Vermont Agency of Transportation
RECEIVED
CK'D BY NVDB, JW, KM, TM OK'D BY JG
March 21, 2017
RESUBMIT No Approved
BY K. Higgins DATE 03/23/2017

STRAFFORD BF 0177(10)

STRAFFORD VERMONT
ABUTMENT SHOP DETAILS

WINGWALL WW3 GEOMETRIC DETAILS

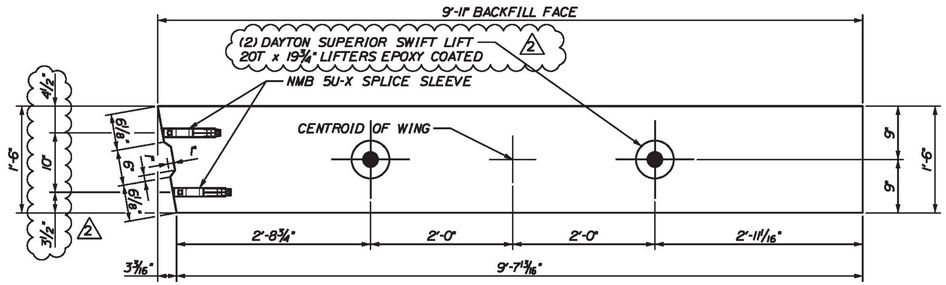
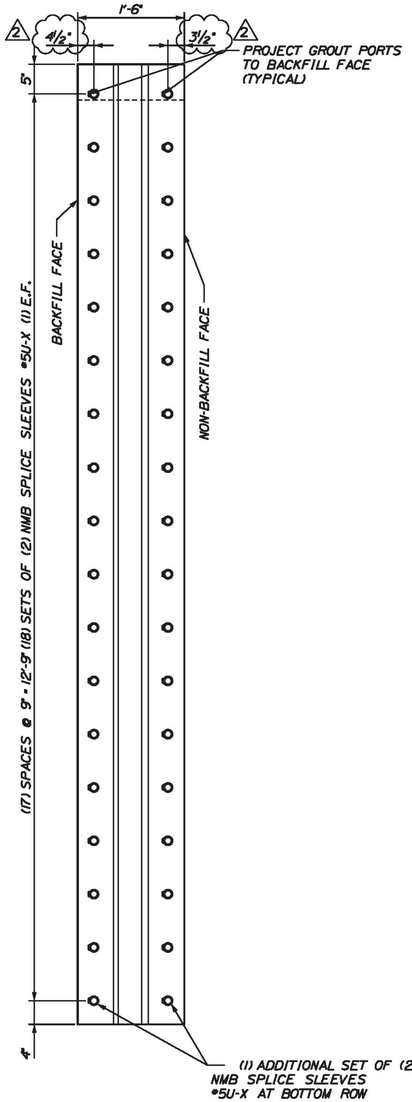
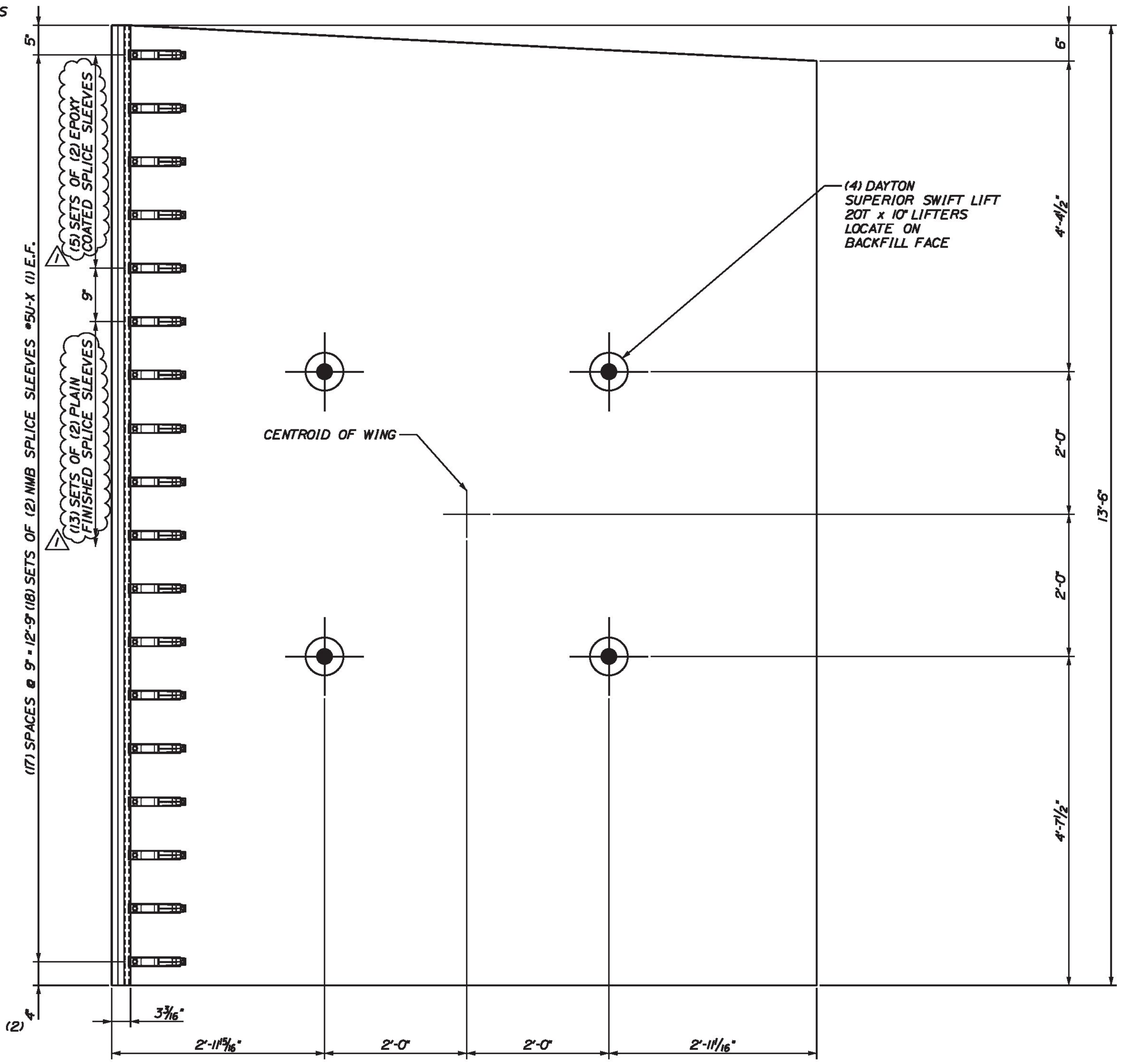
SHOP NOTE:
ALIGNMENT OF SPLICE SLEEVES INTO ABUTMENT SEGMENT IS CRITICAL. USE A TEMPLATE TO ENSURE REBAR WILL FIT INTO GROUTED SPLICERS IN WING

PATCH LIFTING HOLES WITH GROUT FROM VTRANS OVERHEAD GROUT APPROVED PRODUCTS LIST

(PROVIDE ADDITIONAL SPLICE SLEEVES FOR VTRANS TESTING PER SPECIFICATION)
